Sandria Butler
Senior Planning Officer, Alpine Resorts Team
Department of Planning Housing and Infrastructure
PO Box 36
JINDABYNE NSW 2627

Approved Application No 24/16458

**Additional information request (RFI 3) Email 15/01/2025 – DA24/16458 (PAN-481631)
Replacement Lift Hut – Perisher Quad Express.**

Image of the current hut internal finished floor level (FFL) which will be the same as the replacement hut in relation to the existing slab which will remain in place.

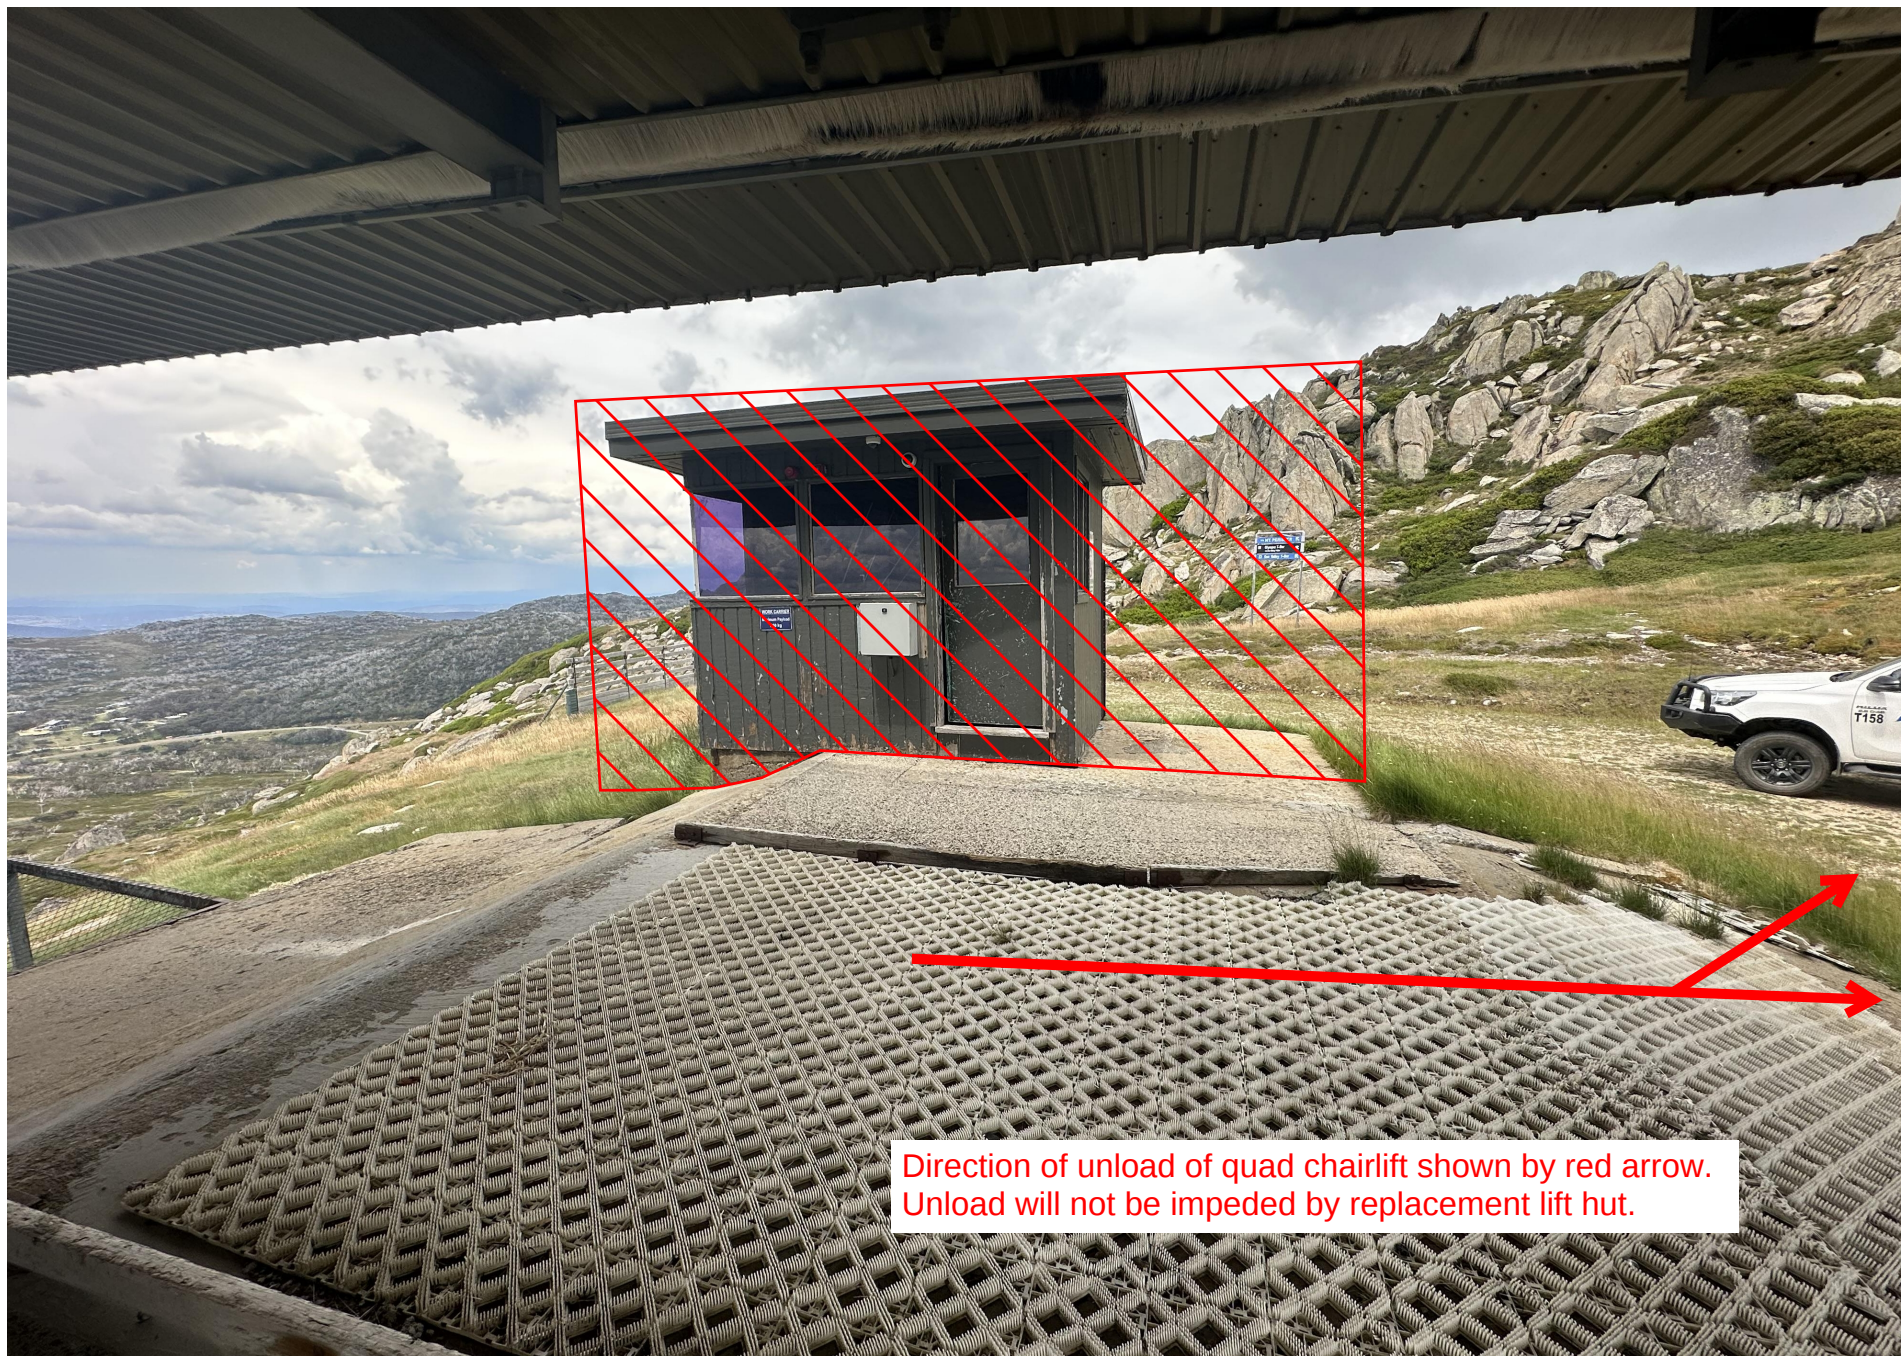
Updated plans with the finished floor level (FFL) of the hut floor have been prepared. The floor level of the proposed hut will be consistent with that of the existing hut to be replaced as the level of the top station platform is to remain unchanged and the hut must correspond to that height for operational reasons. The proposed hut will have no impact on the unload of the chairlift which will operate as per existing gradients with no obstruction provided by the replacement structure.

As discussed, photographs (rather than a redrafted architectural plan) showing the relationship between the existing hut, existing unload area and existing slab are attached.

The proposed FFL of the hut floor will be +250mm from the existing slab as per existing hut floor level. The step up into the hut will be at +300mm as per photograph.

Existing top station deck slab to remain

The red line is the proposed Finished Floor Level (FFL) of replacement hut

Existing hut and existing slab height in relation to the proposed shed interior finished floor level (FFL) shown in green

Proposed replacement hut FFL = +250mm

Existing Deck FFL = 0mm

No change proposed to existing top station deck slab

Direction of unload of quad chairlift shown by red arrow.
Unload will not be impeded by replacement lift hut.

Top Station deck in relation to existing and proposed replacement lift hut (depicted by hatching), illustrating the relationship of the proposed replacement shed in relation to the existing slab height and offload area. Direction of offload to demonstrate that the replacement hut location will not impede the operation of the lift and offload.
